SR-160 TO SR-500 MODIFICATION

The SR-160 is the predecessor of the SR-500. They took the SR160 made a few ckt changes to improve the overall performance and used different final tubes. They then replaced the PS-150 with the PS-500 family of power supplies.

PA SOCKET REWIRE

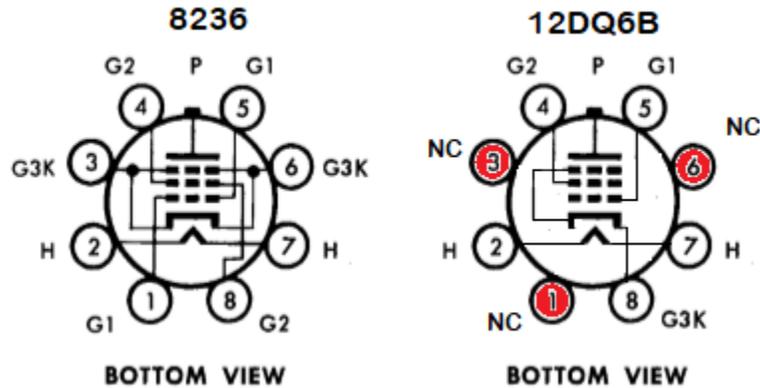
The PA rewire looks to be a simple process. However, the 12DQ6B has unused pins and the 8236 does not. The unused pins in the SR-160 were used as component mounting points. Next the filaments are 12.6v for the 12DQ6B and 6.3v for the 8236

The resistors R103 and R102 and capacitors C113 and C115 are good where they are. The grounds on pin 8 of both tubes must be removed. Pin 8 will remain open, no connection.

The most common filament wiring sees a brown wire coming into the pa cavity and connecting to pin 7 of V16. Another brown wire goes from pin 7 of V16 to pin 2 of V15. Pin 2 of V16 and PIN 7 OF V15 connect to ground.

In the SR-160 the No Connection socket pins 3 and 6 of V16 were used to mount and connect C111, C112 and L11. A bit of mechanical reengineering will be required to install a terminal strip or a couple standoff insulators to mount these components. These parts could be located outside the transmitter cavity, BUT if they are, C111 should be mounted inside the cavity from the bottom end of R94 and one of the gnd lugs on the socket of V15.

Remove the ground from pin 2 of V16. Disconnect the wire going from V16 pin 7 to V15 pin 2 from V16 pin 7 and connect it to V16 pin 2.
